Access Compliance Report

Public Rights-of-Way (Curb Ramps)

Intersection ID: N/A	Main Street: ALLEGIANCE DR	Cross Street: TANYARD LN	Location: S
ADA ID: 4E3136BDBEB5	Ramp Type: Perp	Initial Pass/Fail: Fail	Overall Compliance: No
Severity Score: 12.5			
Codes/Mitigation Info/Possible Solution		Field Measurements/Component Compliance

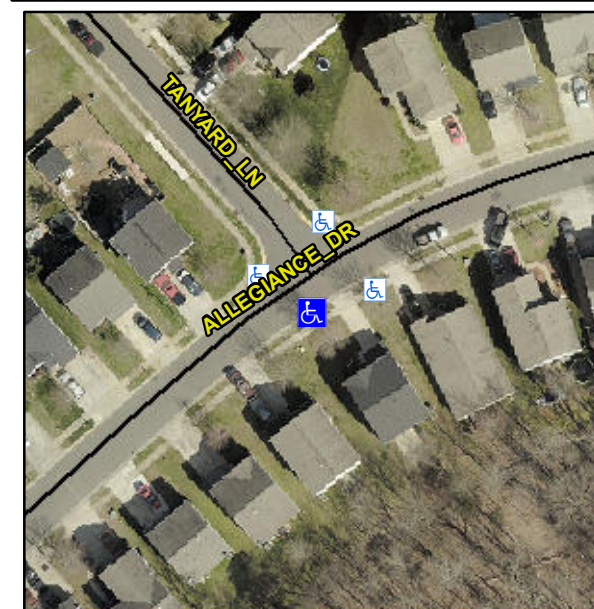
Not Found, R304.2.2

Compliance	Description	Data	Compliance	Description	Data
N/A	Ramp Length (in)	48.0	No	Ramp Slope (%)	9.5
Yes	Ramp Width (in)	49.0	Yes	Ramp XSlope (%)	0.3
N/A	Flare Type LT	N/A	N/A	Flare Type RT	N/A
N/A	Flare Slope LT (%)	N/A	N/A	Flare Slope RT (%)	N/A
N/A	Flare Traversable LT?	No	N/A	Flare Traversable RT?	No
N/A	Landing Length (in)	N/A	N/A	DWS Provided?	N/A
N/A	Landing Width (in)	N/A	N/A	DWS Contrast?	N/A
N/A	Landing Slope (%)	N/A	N/A	DWS Length (in)	N/A
N/A	Landing X Slope (%)	N/A	N/A	DWS Full Width?	N/A
N/A	Landing Curb? (Y/N)	N/A	N/A	DWS Offset (in)	N/A
N/A	Shared Landing?	N/A			
N/A	Gutter Ponding?	N/A	N/A	Gutter Slope (%)	N/A
N/A	Gutter Lip Ht (in)	N/A	N/A	Gutter X Slope (%)	N/A
N/A	Painted X Walk1?	No	N/A	Painted X Walk2?	N/A
	X Walk 1 Direction	To NW		X Walk 2 Direction	N/A
N/A	X Walk 1 Width (in)	N/A	N/A	X Walk 2 Width (in)	N/A
	X Walk 1 Slope (%)	3.4		X Walk 2 Slope (%)	N/A
	X Walk 1 X Slope (%)	2.3		X Walk 2 X Slope (%)	N/A

Remove & Replace Entire Ramp.
